# EXPLANATION OF SIGNIFICANT DIFFERENCES

## MAXEY FLATS DISPOSAL SITE FLEMING COUNTY, KENTUCKY

EPA Region 4

September 2014

Illustration of Changes Made to Final Cap for Maxey Flats

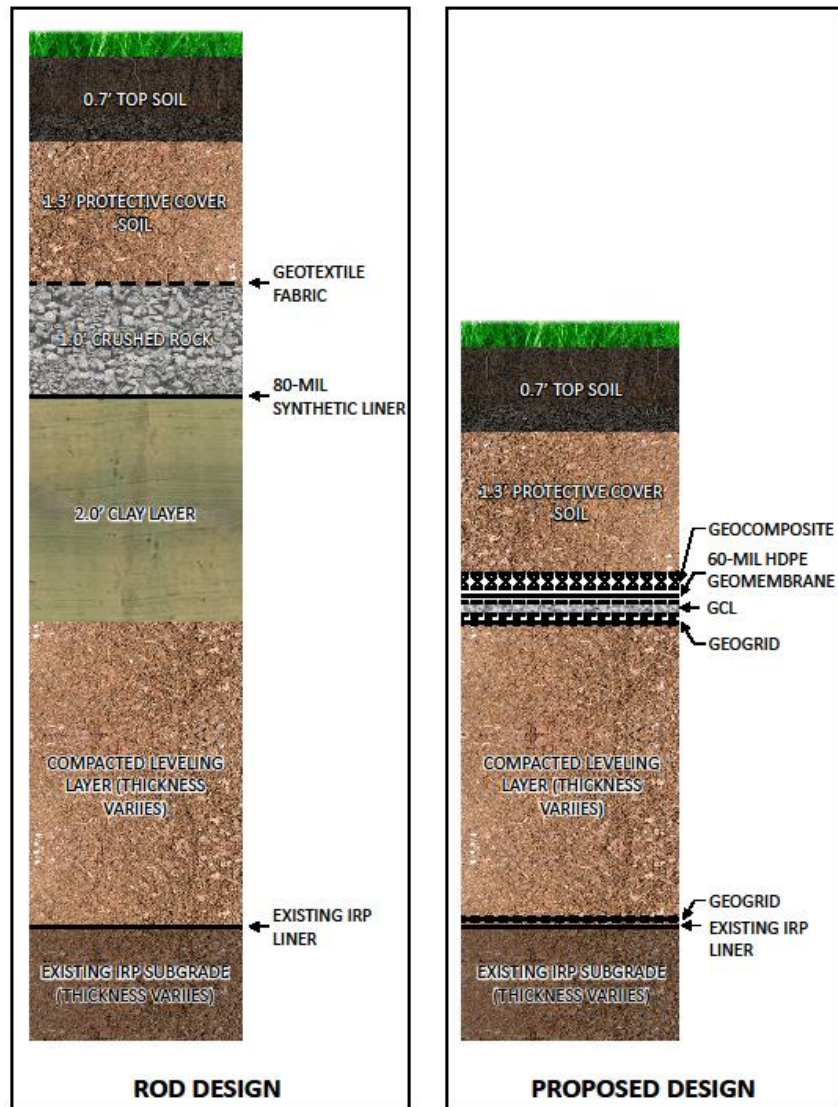
The final cap changes proposed during the remedial design include: 1) use of a geosynthetic clay liner (GCL) in-place of the two-foot layer of compacted clay with permeability not exceeding  $1 \times 10^{-7}$  cm/sec described in the ROD; 2) use of a 60-mil geomembrane rather than an 80-mil geomembrane described in the ROD; and 3) use of a geonet drainage layer in-place of the one-foot of crushed rock with a minimum permeability of  $1 \times 10^{-3}$  cm/sec. Additionally, geogrid reinforcing layers are being added to ensure the stability of the cap over the trenches.

First, a geosynthetic clay liner (GCL) was proposed to replace the two-foot layer of compacted clay described in the ROD. GCLs

are manufactured under controlled conditions and therefore have more consistent quality than field compacted clay barriers. A GCL is an industry-standard product that is designed to provide equivalent or better infiltration reduction performance to a compacted clay component of a composite cover system. GCLs are easily transported and installed compared to clay barriers, making them less expensive. GCLs use a clay core that is two orders of magnitude less permeable than the currently specified clay with permeability not exceeding  $1 \times 10^{-7}$  cm/sec. There are fewer field quality control requirements. The clay swells when wetted, leading to an increase in the thickness of and enhanced infiltration barrier capacity for the GCL.

Second, 60-mil high-density polyethylene (HDPE) geomembrane is more available and easier to install and thus will cost less than the 80-mil material. The 60-mil HDPE, when incorporated with the designed protective layers, will provide sustainable performance for the Maxey Flats cap. The proposed HDPE geomembrane is the industry-standard material for use in this application. It has demonstrated chemical stability, durability, and hydraulic barrier performance demanded by this application. This textured (on both sides) geomembrane material offers superb frictional resistance and improved cap stability. The 60-mil thickness offers the optimal combination of environmental protection, flexibility, conformability, and constructability and cost.

Third, a geonet drainage layer was proposed to replace the one-foot of crushed rock with

a minimum permeability of  $1 \times 10^{-3}$  cm/sec described in the ROD. The engineering functions of filtration, drainage, and protective cushion can be provided by a single engineered product. The ROD described design does not provide cushion protection to the geomembrane from the stone to be placed directly on it. The current design does not specify the material to be used to construct the synthetic liner.

Finally, geogrid reinforcing layers are being added to ensure the stability of the final cap. The geogrid adds stability to the cap, reduces the weight of the leveling fill layer, lowers the profile of the cap and thus reduces the erosion potential and improves storm water runoff control, and improves resistance to possible future subsidence.
